**RE: DOUBLE RAINBOW II PARKING LOT (F21-D67) GRADING AND DRAINAGE PLAN
GRADING PERMIT, AND PAVING PERMIT APPROVALS. ENGINEER'S STAMP
DATED 6-25-97.**

**RE: DOUBLE RAINBOW II PARKING LOT (F21-D67) GRADING AND DRAINAGE PLAN
GRADING PERMIT, AND PAVING PERMIT APPROVALS. ENGINEER'S STAMP
DATED 6-12-97.**

GRADING AND DRAINAGE PLAN

DOUBLE RAINBOW II PARKING LOT EXPANSION

WIDE
DRAINAGE
CEMENT
R USE
LOT
21

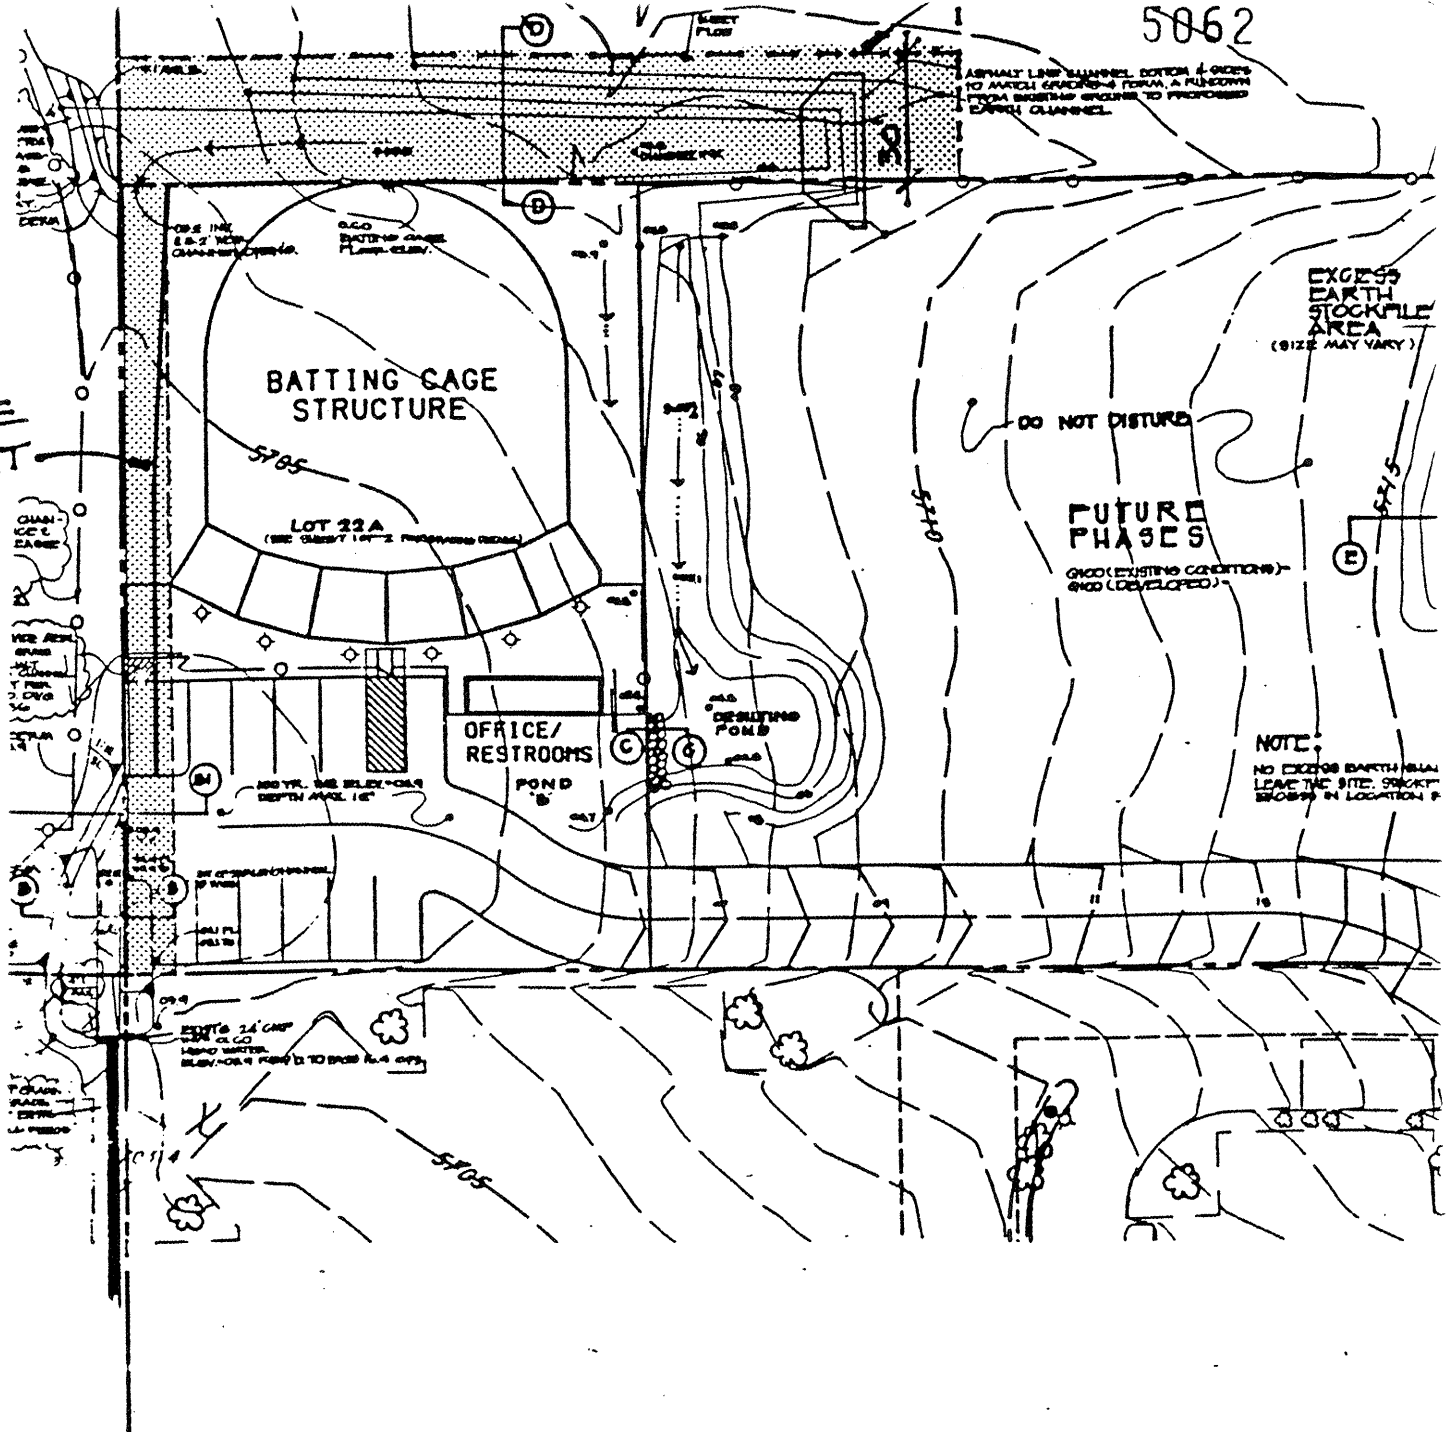
1. It appears that the Grading and Drainage Easement Agreement between lots 21 and 22 was temporary and expired August 30, 1995.
2. How much offsite flow enters the site?
3. No water harvesting will be allowed. If you want use the storm water for irrigation purposes, than you can release less water from you pond. The 4-inch discharge line will be a maintenance problem for the owner. I suggest using a larger pipe with an orifice plate to control your discharge.
4. Please discuss the storm water path once it leaves this site. Does it eventually get to Montgomery?

DRAINAGE PLAN, CALCULATIONS, SECTIONS AND DETAILS, GRADING NOTES DOUBLE RAINBOW II PARKING

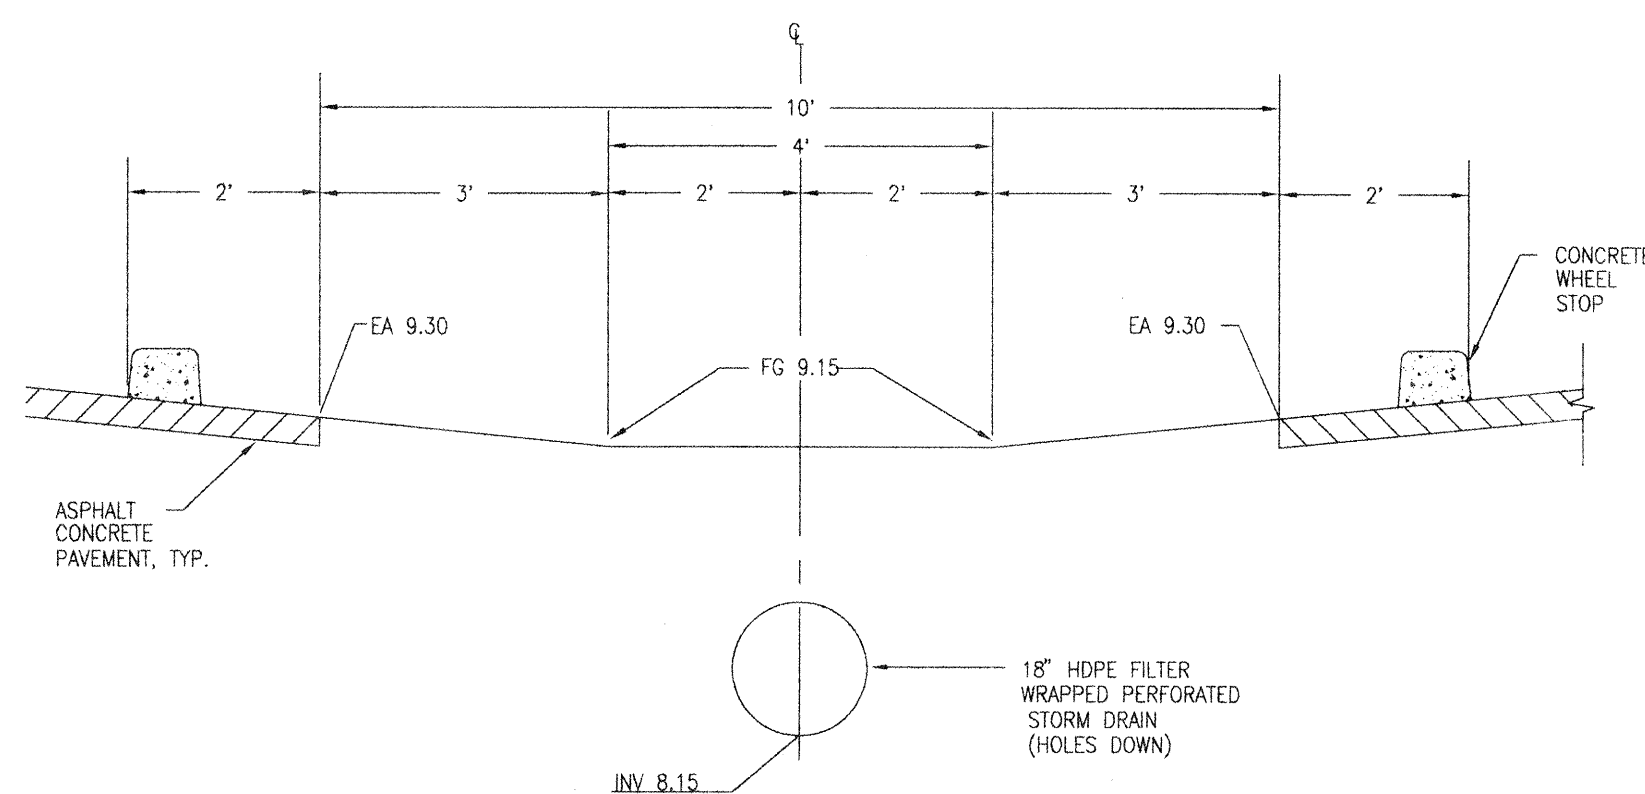
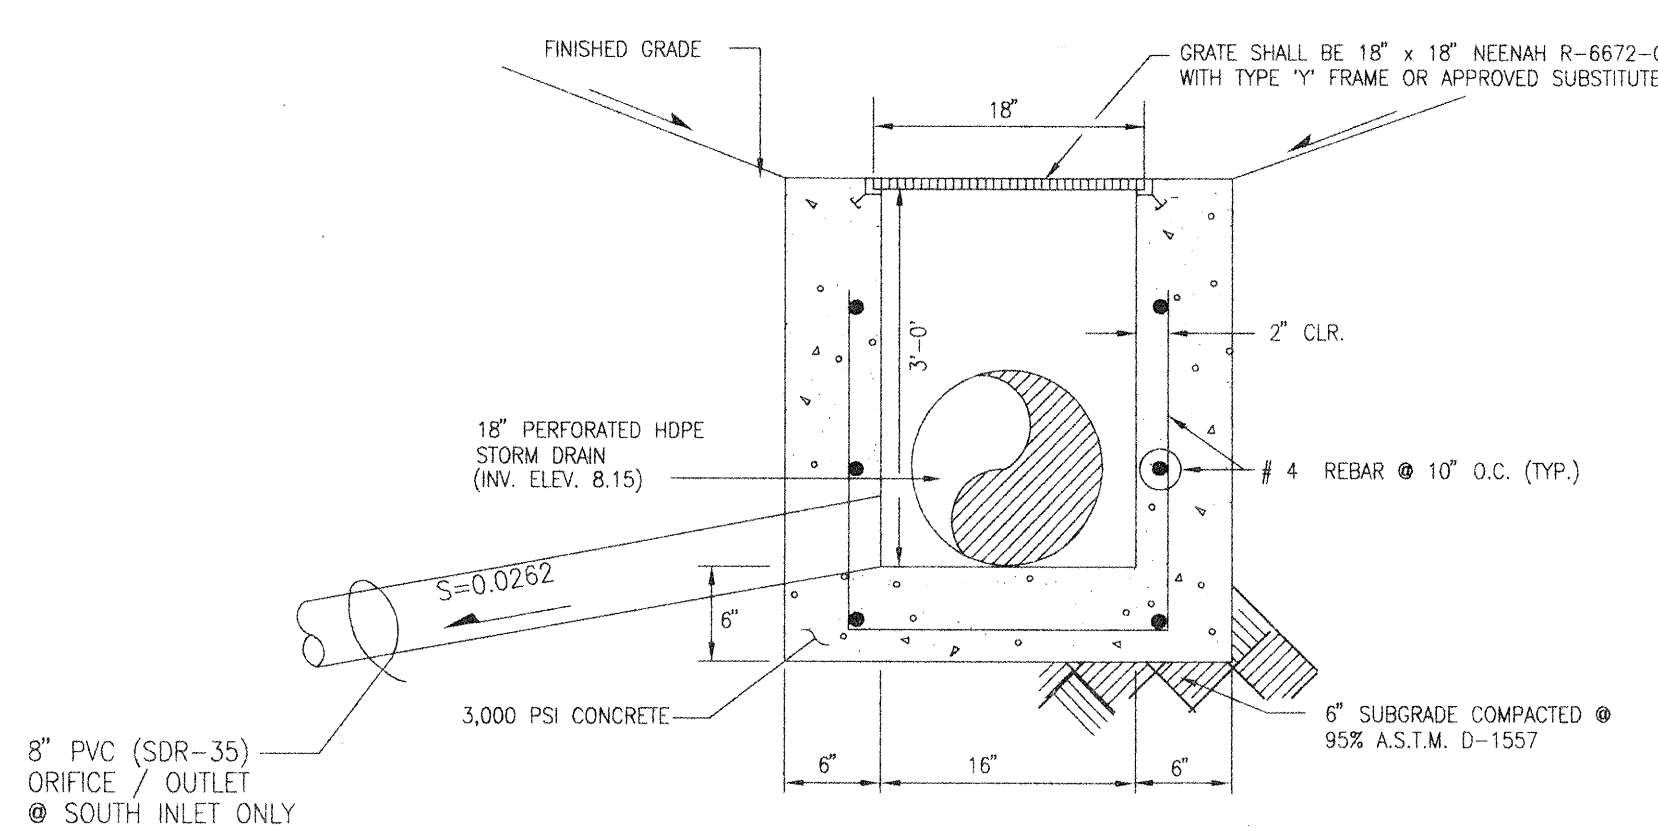
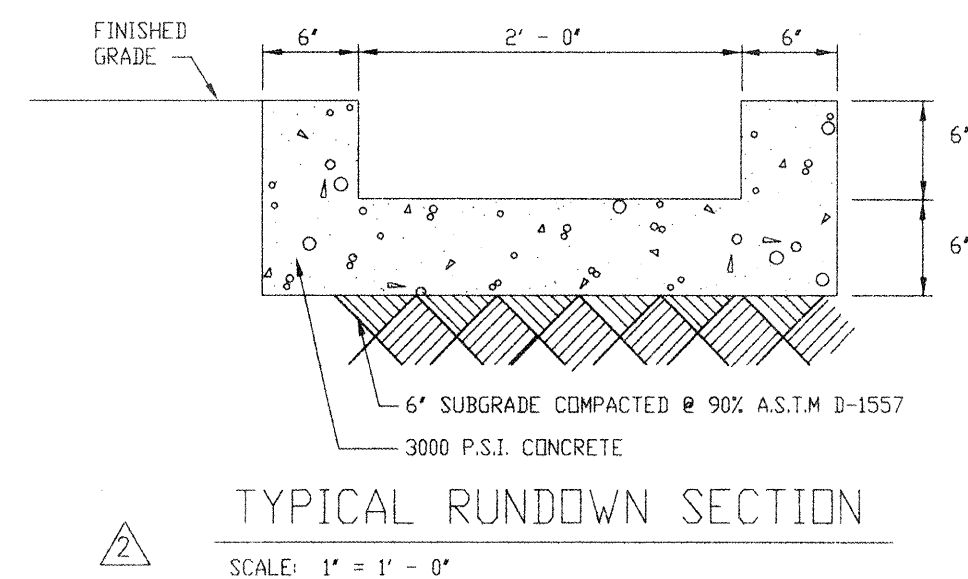
1. Why are you using infiltration? Developed flow can not be used for water harvesting.
2. I am confused by calculation IX (B). Where does 3.1 cfs come from?

$$B. \Delta Q_{100} = 4.7 - 3.1 = 1.6 \text{ cfs (decrease)}$$
